4 March 2021

MAC190962-03LR1

Acoustic Review: Holcim Dubbo Quarry Continuation Project on behalf of Regional Group Australia Pty Ltd

FIGURE 1
PROJECT LAYOUT
MAC190962-03
Holcim Dubbo Quarry
Continuation Project
Acoustic Review

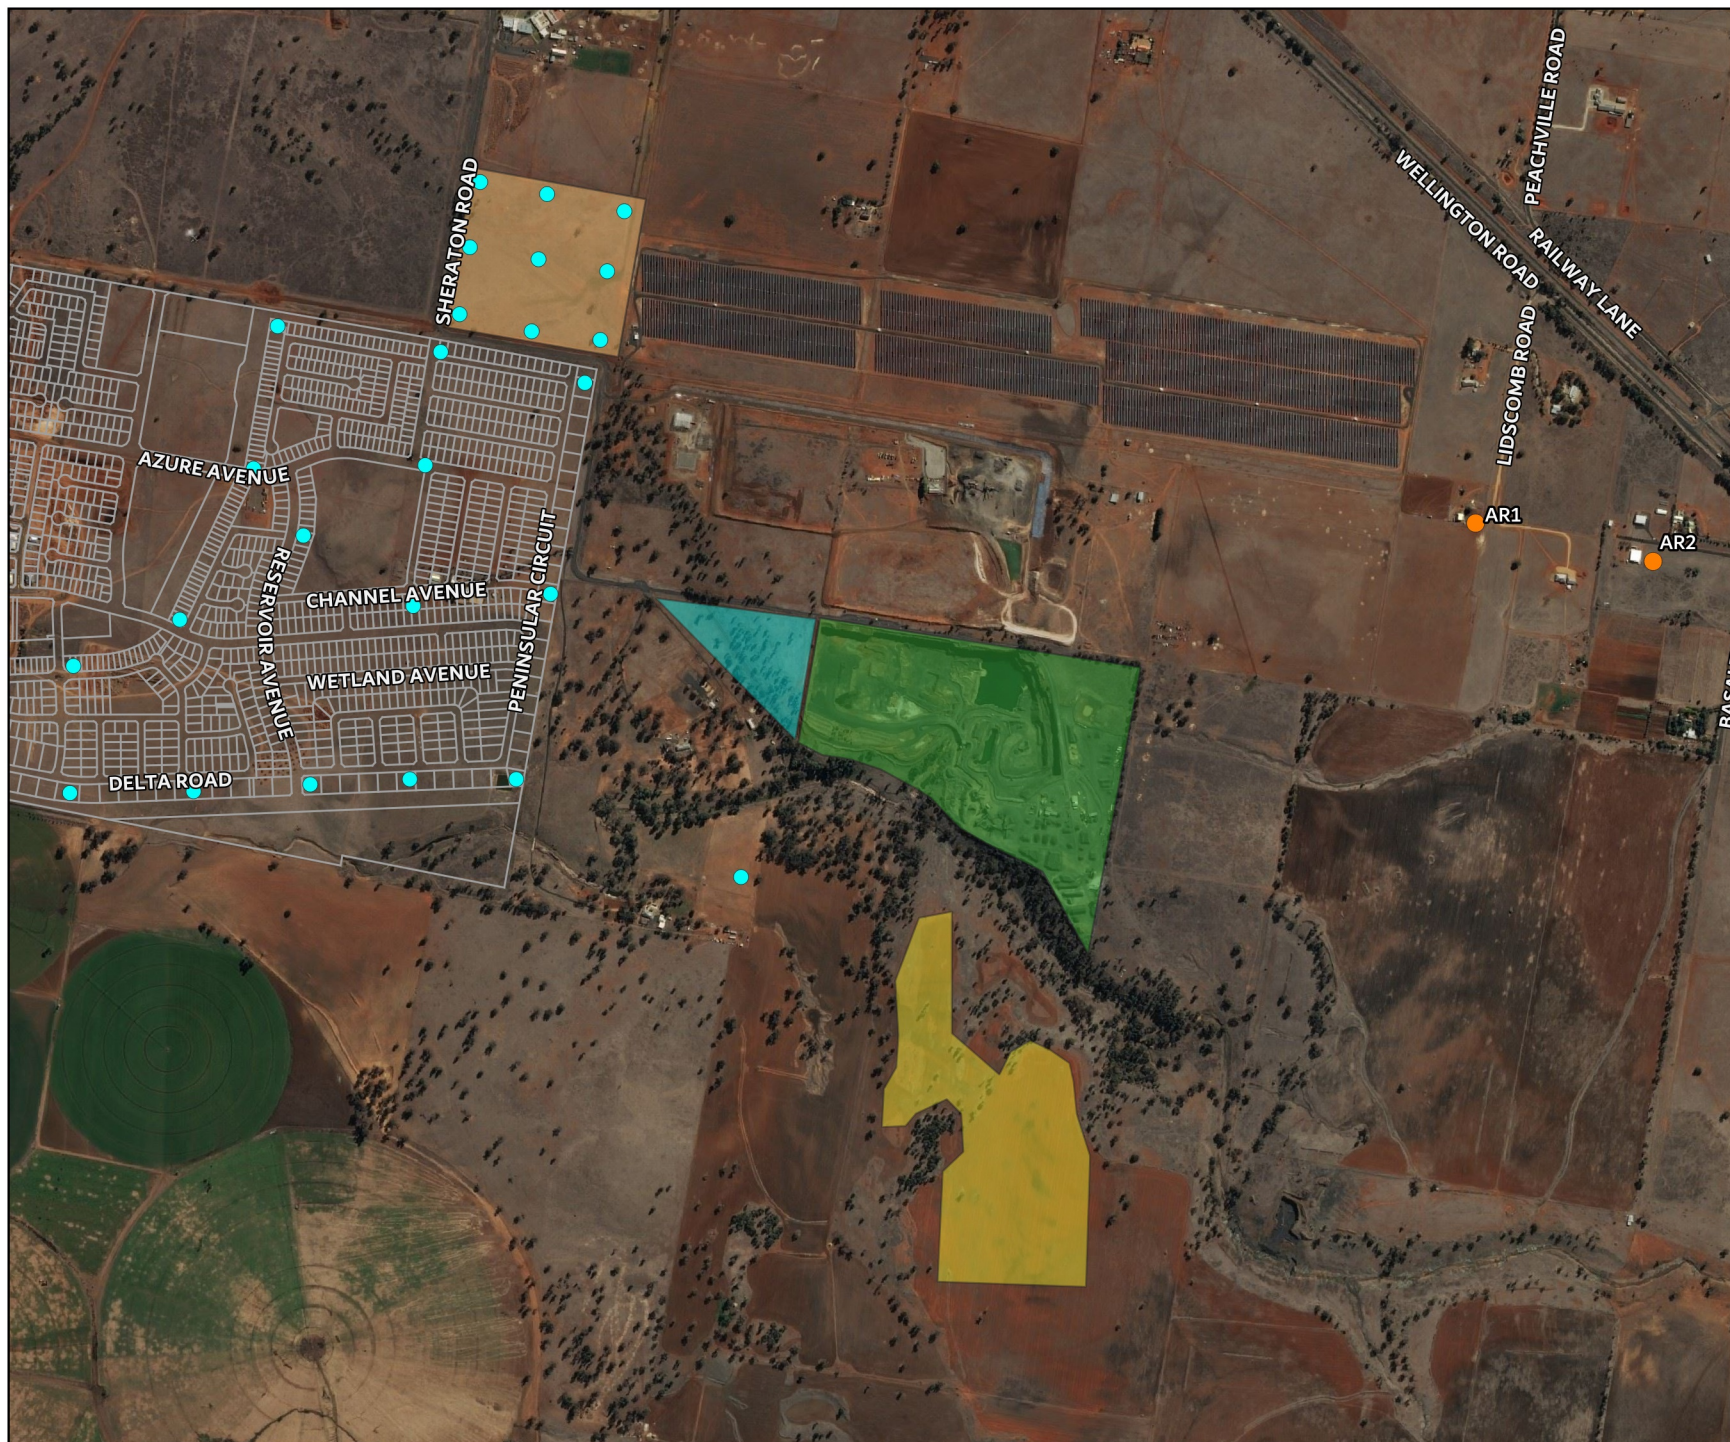
The NVIA has not assessed all the residential receivers within the potentially affected area of influence of the quarry extension. The following receivers were not included in the assessment:

- 4R Lidscomb Road (Lot 32 DP247415);
- 1R Basalt Road (Lot 28 DP247415) – possible second dwelling south of R16;
- Approved dwelling at 25R Sheraton Road (Lot 159 DP754331); and
- Potential future residential receivers in the proposed residential subdivisions.

The NVIA refers to location R23 as an approved residential subdivision (Sheraton Road Estate). The location of R23 is the nearest point of the subdivision to the quarry, however, it is likely that possible future receivers along the Sheraton Road interface that may be affected by road traffic noise which has not been assessed.

The Southlakes Estate is proposed to front the southern portion of Sheraton Road continuing west to Wheelers Lane. Future receivers in the area would be the nearest receivers after locations R1 and R2 identified in the NVIA. The additional receivers and subdivisions are presented in **Figure 1**.

Noise levels from the quarry operations and road traffic should be calculated at the potential future residential receiver locations in the approved subdivisions (Sheraton Road Estate and Southlakes Estate).
